Re: 31-33 N. Airmont Road, Tax Map Section 55-08 Block 1 Lots 10-16, Concept Plan & Subdivision Crown Millwork Offices and Warehouse

Response to Spence Engineering comments dated April 10, 2026

Photo 3: Grasscrete - Current Google Aerial View

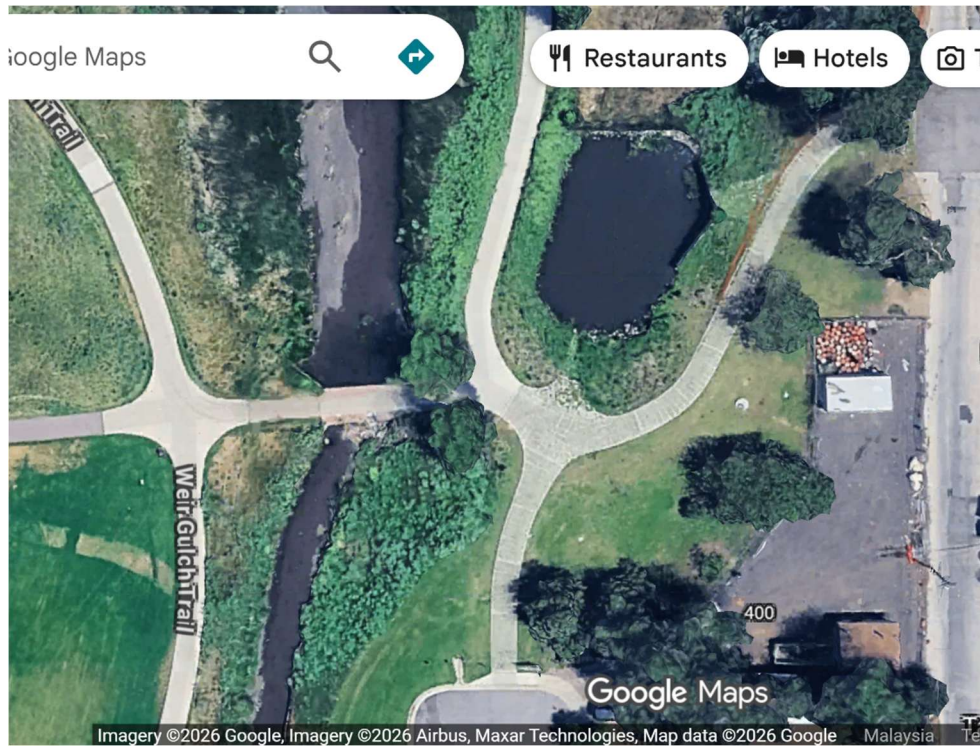
- 3) Comment: *The plan shows all vehicle parking spaces to be grasscrete, along with a truck turning area near the entrance to the proposed parking lot. The grasscrete areas are not visible from outside the site and will not have a visual impact the N. Airmont Road corridor. The drainage analysis takes these grasscrete areas as impervious; therefore the report is conservative and does not rely on infiltration through the grasscrete to meet stormwater requirements. The applicant is using these areas to reduce development coverage; 62.5% of the grasscrete is impervious. The applicant shall submit evidence (photos) of similar uses showing different timeframes from installation (i.e. 1 year, 3 years, 5 years after installation).*

Response: Please see photo exhibits attached at the end of comment responses showing a project Barnum Park in Denver, Colorado. Photos of the site immediately after installation, 1 year after installation, and Current Google aerial and street view have been included.
